United States Nuclear Regulatory Commission
Document Control Desk
Washington, D. C. 20555-0001Subject: Response to Questions Regarding the 2002 Steam Generator Tube Inspections
(TAC No. MB9541)

RESPONSE TO QUESTIONS ON LICENSEE'S RESPONSES
TO REQUEST FOR ADDITIONAL INFORMATION
DAVIS-BESSE NUCLEAR POWER STATION
2002 STEAM GENERATOR INSPECTION (TAC No. MB9541)

Voltage Distribution for Dents Between LTS and 14S
 DBNPS SG 2-A 02/02 13RFO

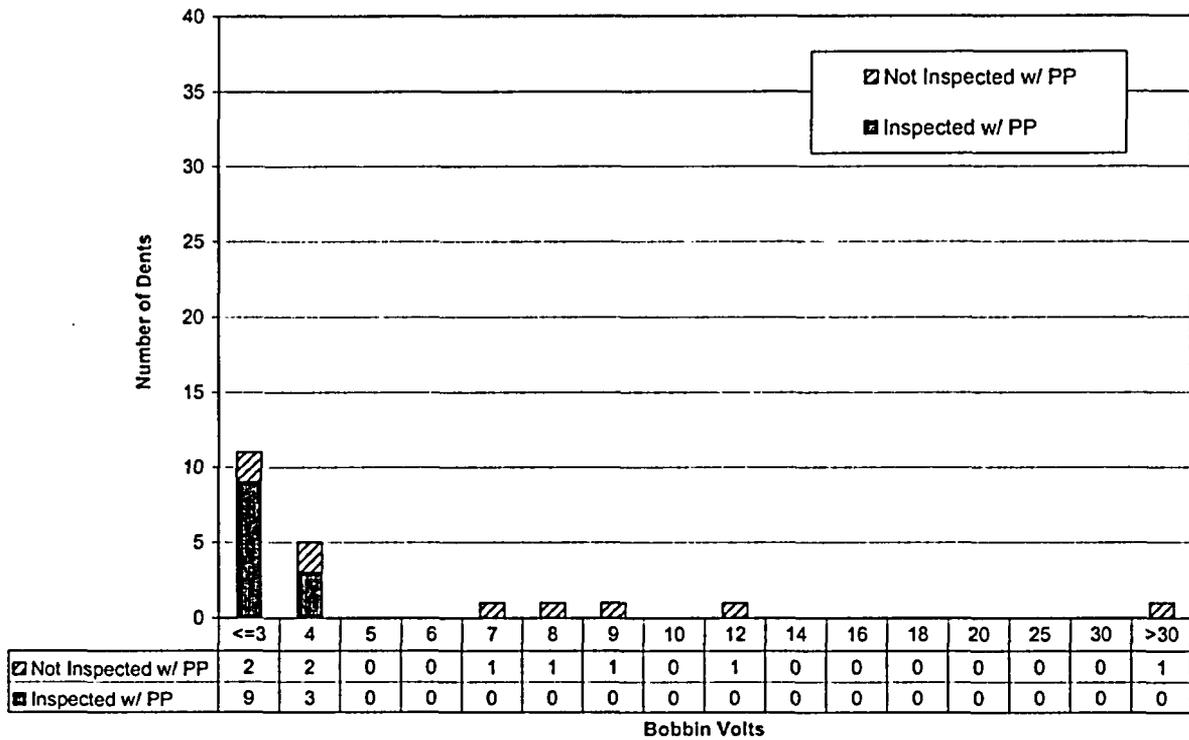
For the dents not examined during the 2002 outage, please describe the methodology used to assess the integrity of these tubes for the period of time between inspections. Include in this response, the size distribution of the dents not inspected and an assessment of whether the bobbin would have detected axial and circumferential cracks at these locations (given the size of the dent).

As previously stated, 100% of the dents located at or above the 14th TSP were inspected during 13RFO, and for dents below the 14th TSP, the DBNPS completed a 100% sample in three cycles with no indications of degradation present in any of the inspections. As requested, the figures provided below indicate the inspected versus uninspected population of dents in the region below the 14th TSP (not including dents at or in the LTS region) during the 13RFO inspection. Note that the 30 volt dent in A-61-109 was inspected in 12RFO with a +Point probe and no degradation was detected (dent present in history). Sampling in both OTSGs at the LTS sludge and dented region is accomplished under a separate inspection program.

no expansion of the dent inspection scope was performed at 13RFO and the tube integrity analyses did not include any adjustments for the uninspected dent population. As demonstrated by the Figures, the inspected population provided a sufficient interrogation of dents such that if degradation existed in this region, the sample would have been sufficient to provide a high probability of detecting active degradation in the sample. At the next scheduled inspection of the OTSGs, the DBNPS is planning on inspecting 100% of all dents in all areas of the OTSGs, as well as preventive plugging of significant dents in the region at or above the 14th TSP in the periphery (damaged from auxiliary feedwater (AFW) header issues), where existing conditions (temperature, flow, loads) could accelerate tube degradation at the dented area.
